**FINAL DRAINAGE REPORT
FOR
STERLING RANCH FILING NO. 5**

Project No. 25188.16

PCD Filing No: XX-XXX ← SF241

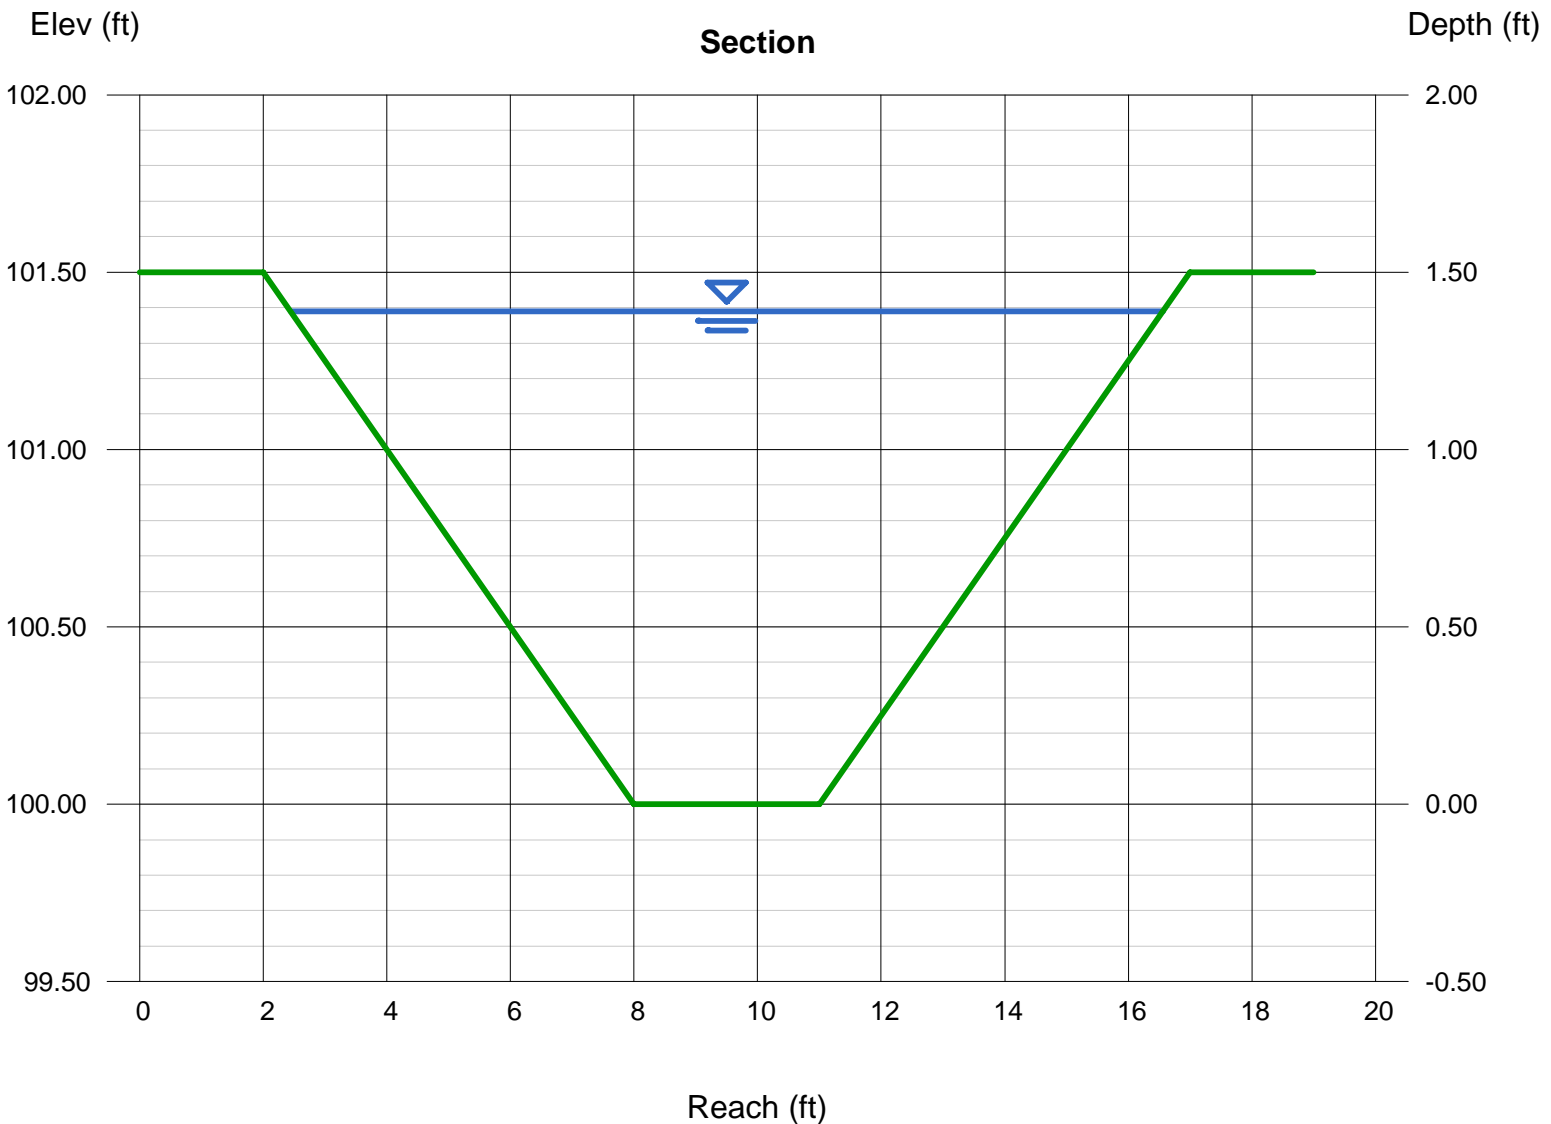
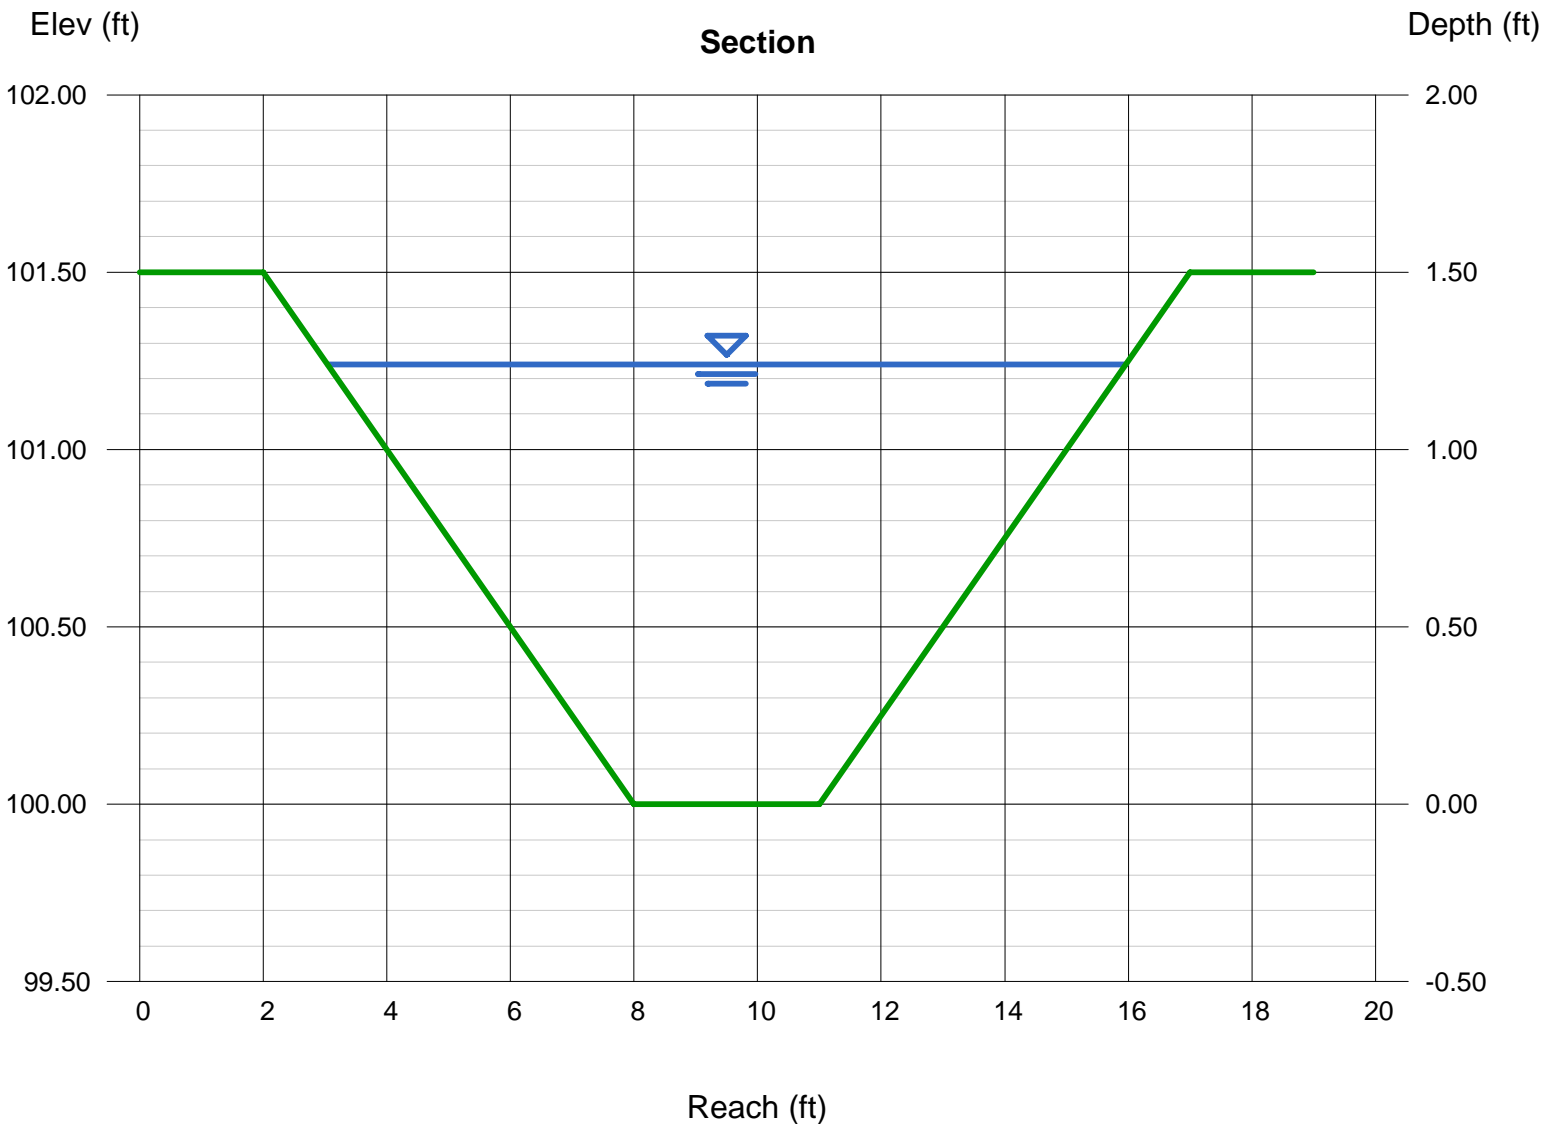
Provide calculation for DP2 emergency overflow swale

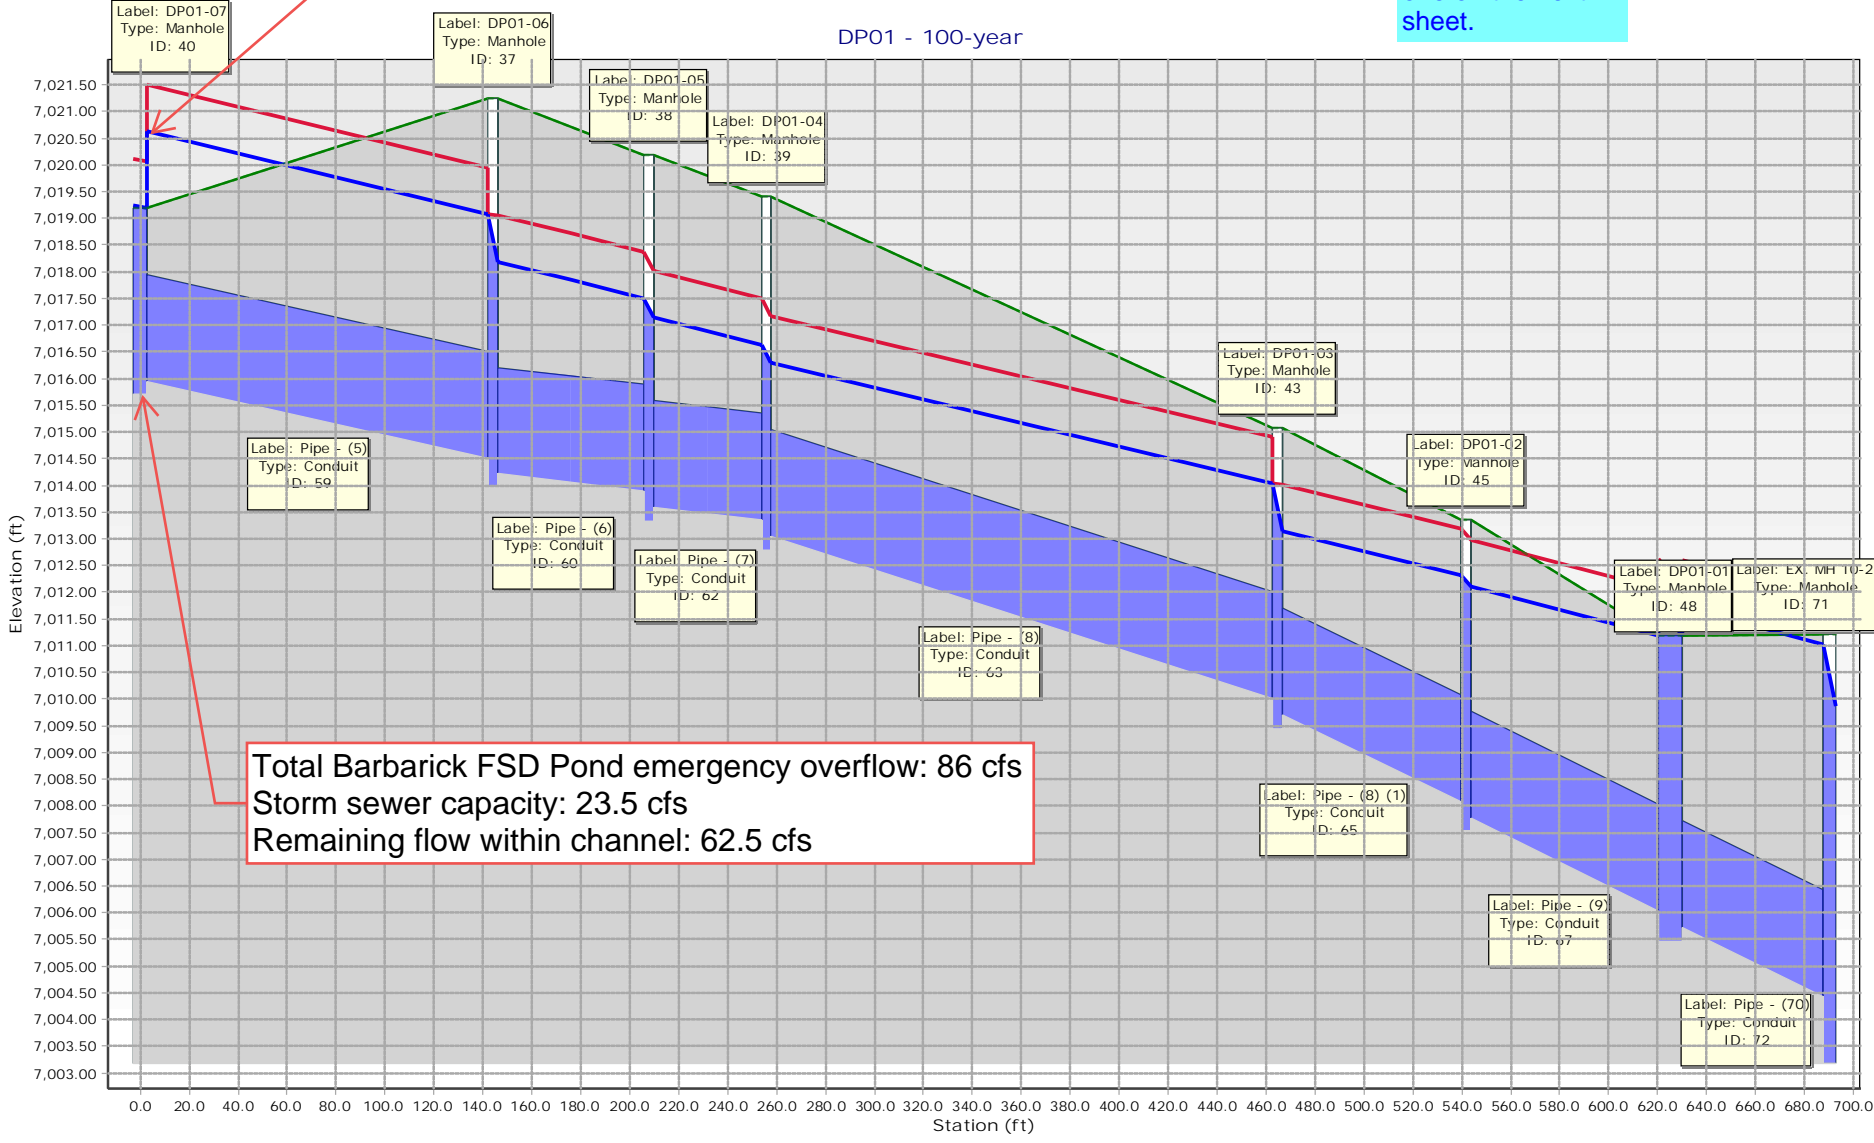
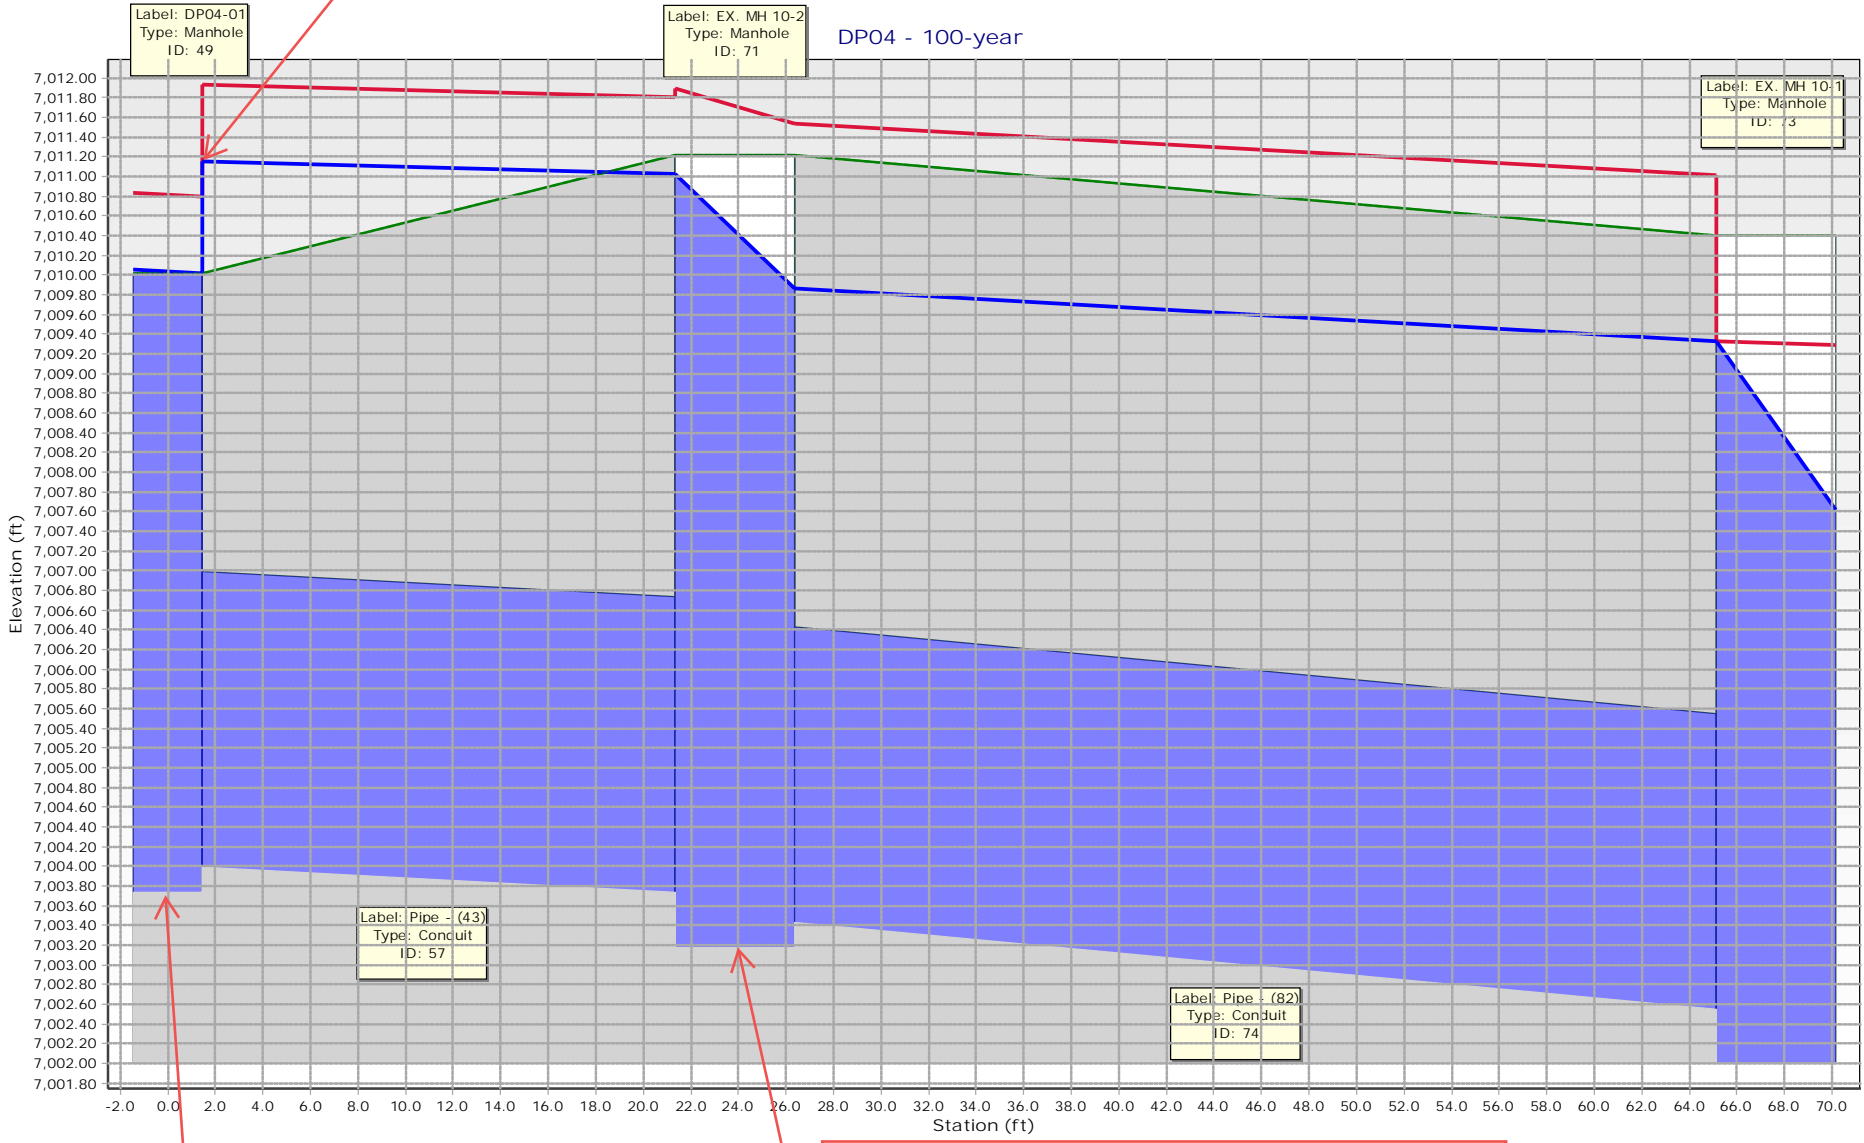
Show HGL elevations around inlets to show flows remain with int channel

Provide StormCAD tables that correspond to this profile and the one on the next sheet.

Show HGL elevations around inlets to show flows remain with int channel

Inlet located within a channel and flows will not exit the channel section.

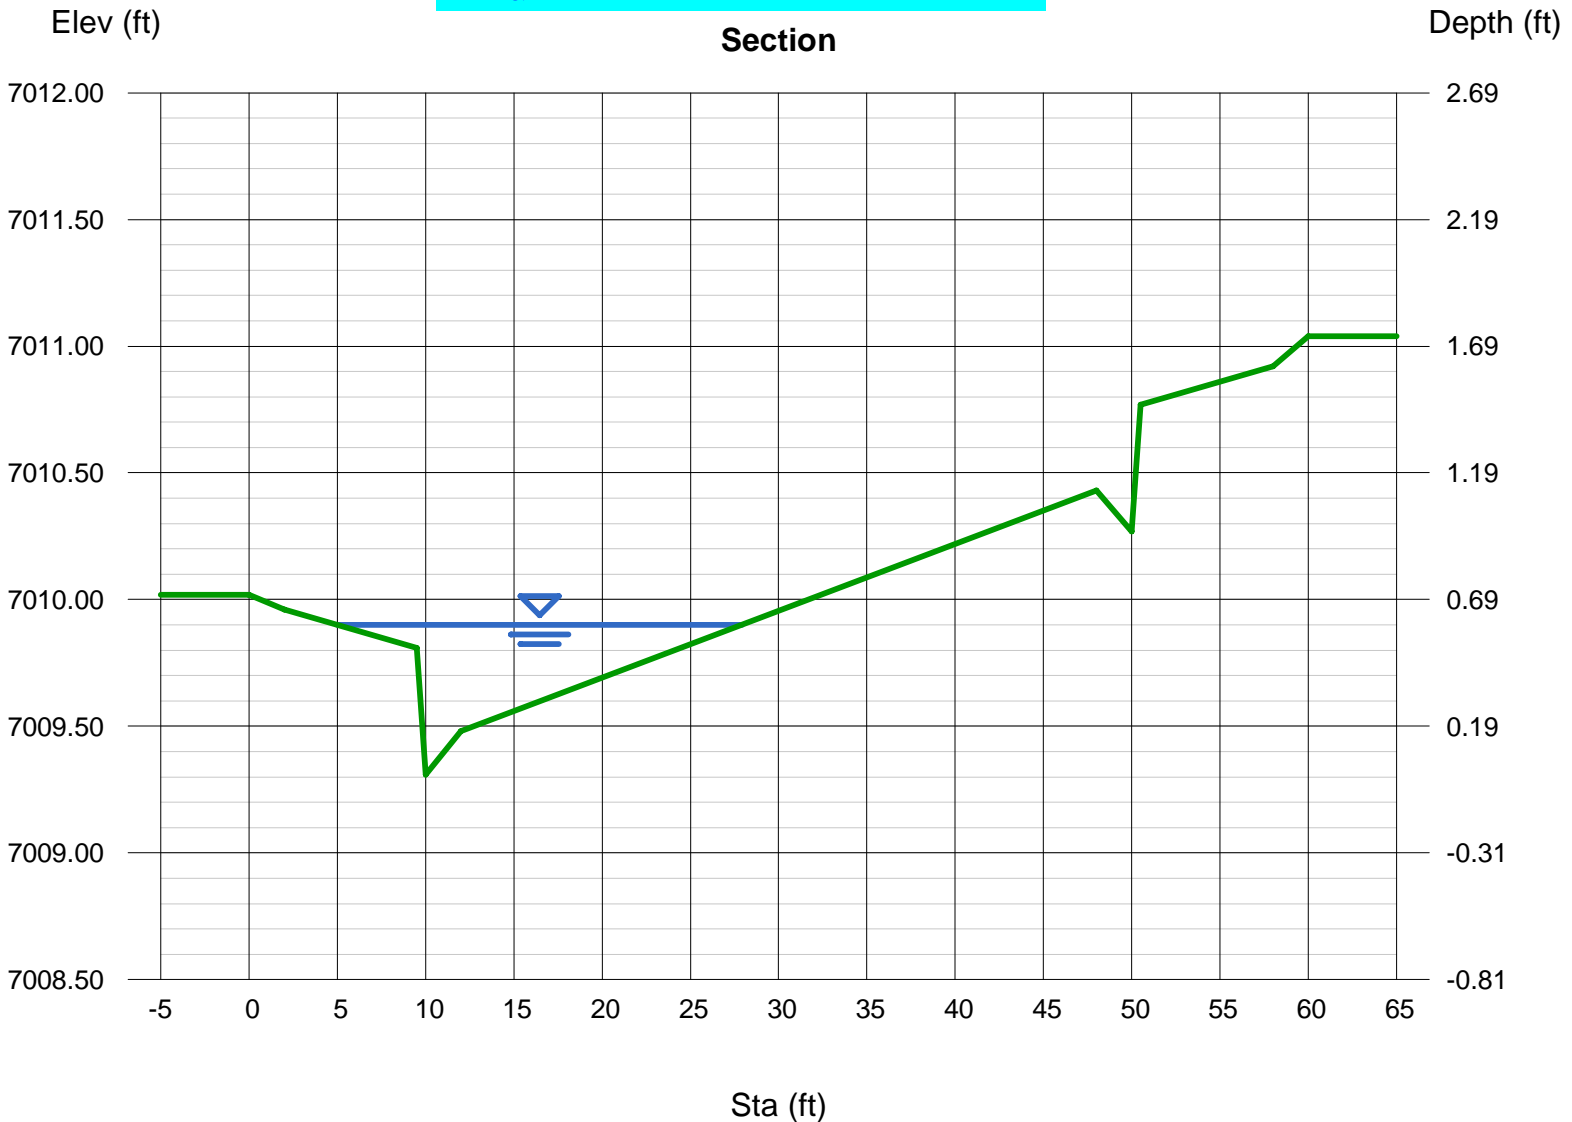
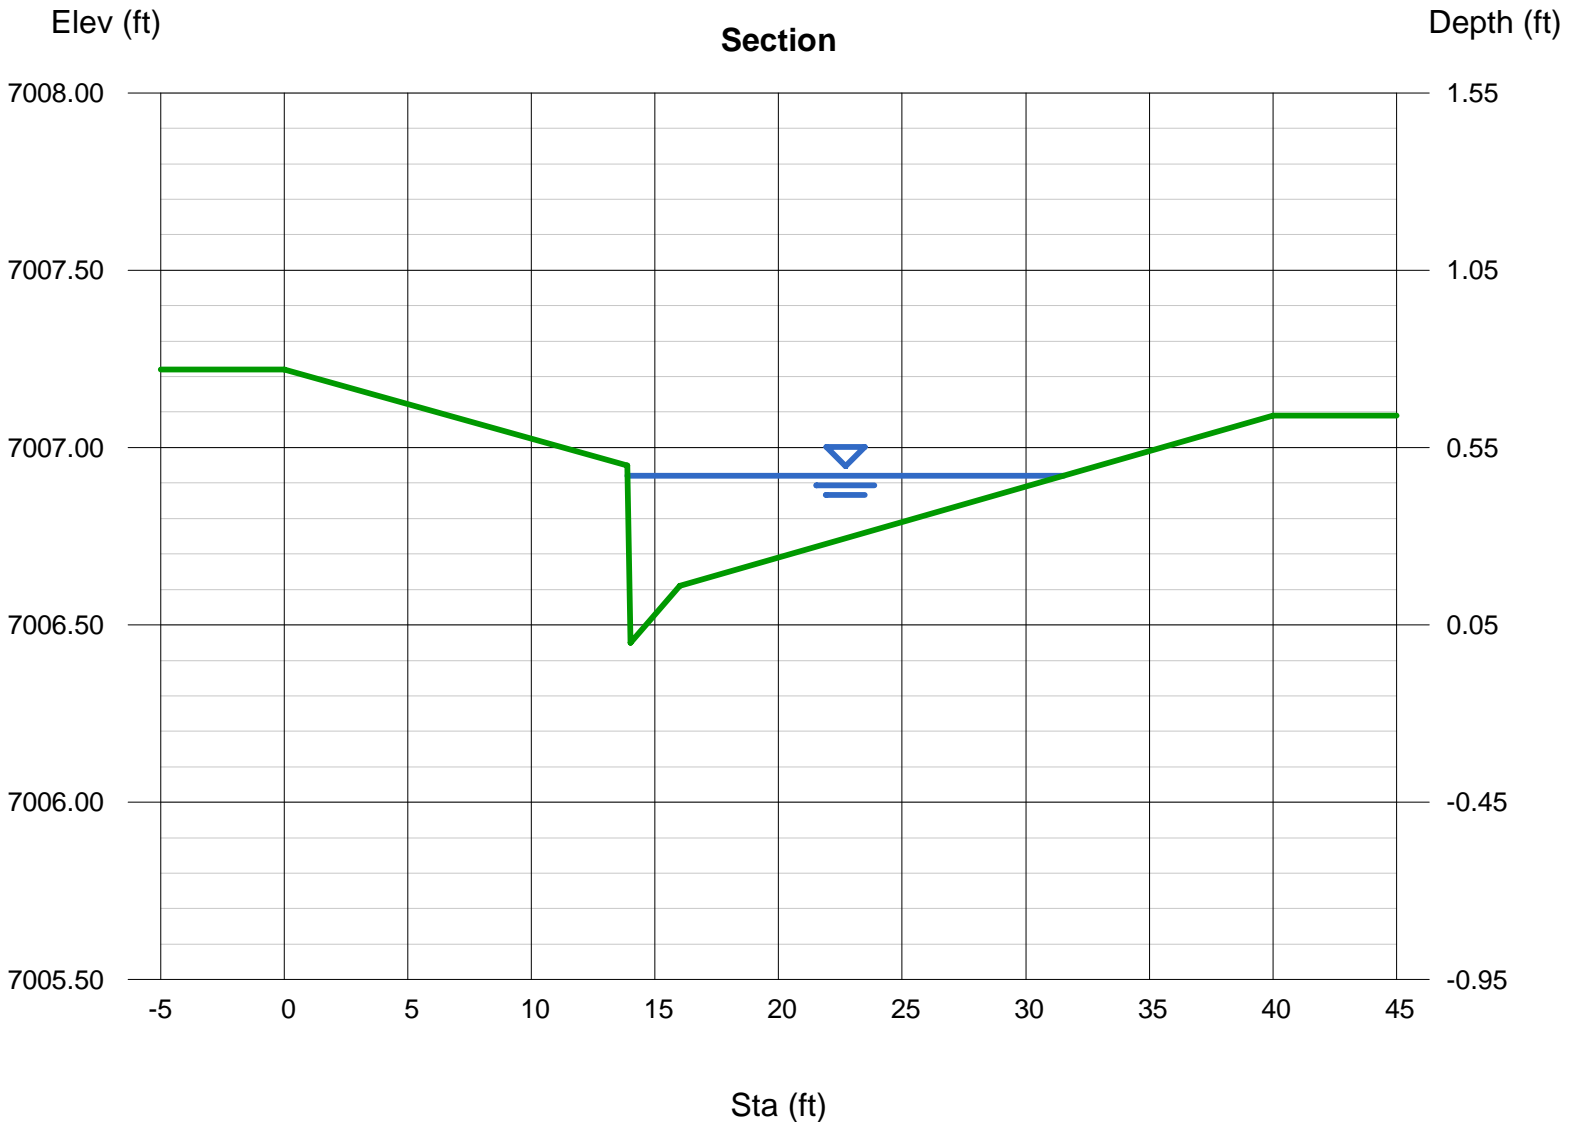
Provide an additional analysis for flow of at least 17.5 cfs (Flow from DP 8 & emergency flows from DP3 & DP5). Worse case scenario would also include emergency flows from Barbarick Pond & DP 1 & 2.
